123.NET FIBER HUT JSP22-49

Approval at the request of Moiseev/Gordon Associates, Inc., for Preliminary Site Plan approval for a new 200 square foot telecommunication shelter. The subject property is 5.98 acres and is located at 48735 Grand River Avenue in Section 17, south of Grand River Avenue and east of Wixom Road. The southern portion of the property is zoned I-1, Light Industrial and the northern portion is zoned B-3, General Business.

PLAN REVIEW CENTER REPORT

JSP 22-49

SHRUB PLANTING DETAIL

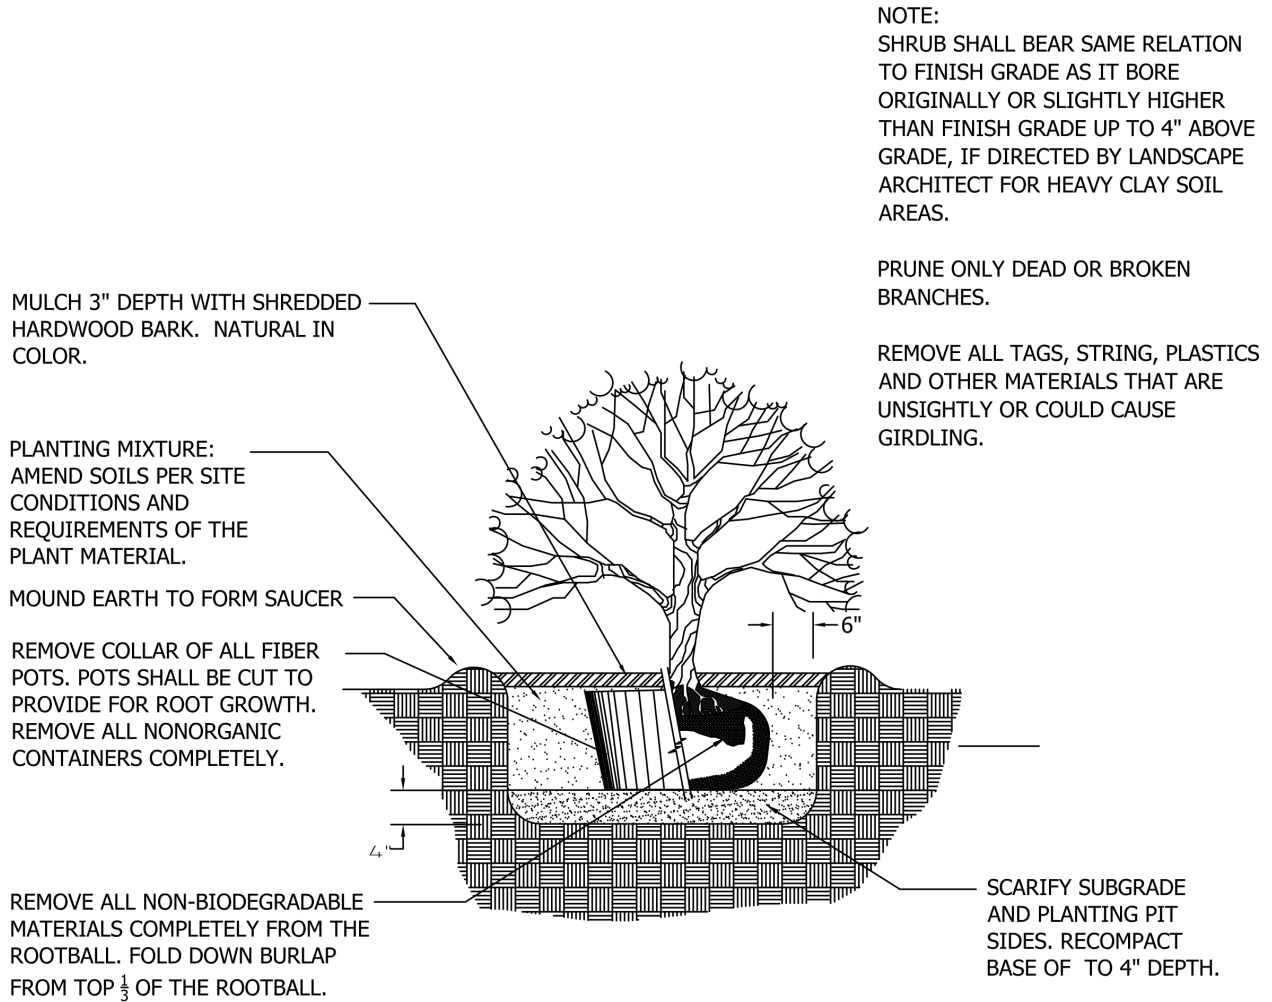
Please add the detail below to sheet A-1.
